SERVICE BULLETIN

APPLICABILITY: 2015MY Outback Models

NUMBER: 12-193-15

SUBJECT: Design Change to Rear Seat Backrest Striker

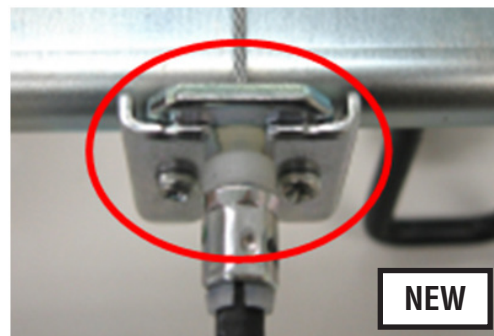
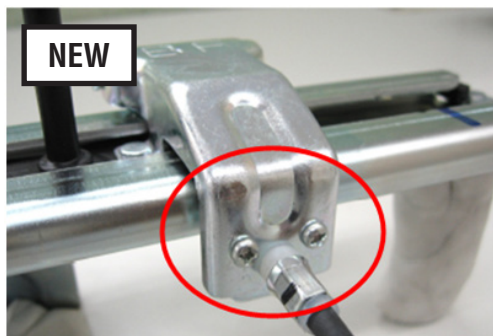
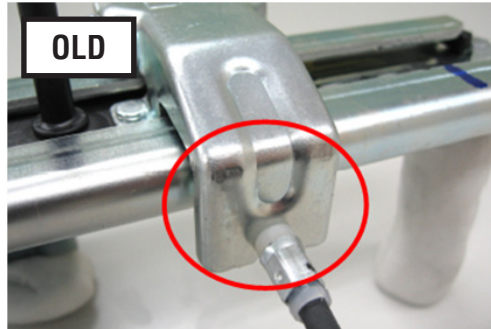
The photos below show the difference between the “old” part and the “new”. The new striker assembly incorporates an additional bolted-in retaining bracket to enhance retention of the cable.

The new striker assemblies were incorporated into production starting with VIN F*304692.

DESCRIPTION	PART NUMBER
STRIKER B ADJ OBK RH	64375AL02A
STRIKER B ADJ OBK LH	64375AL03A
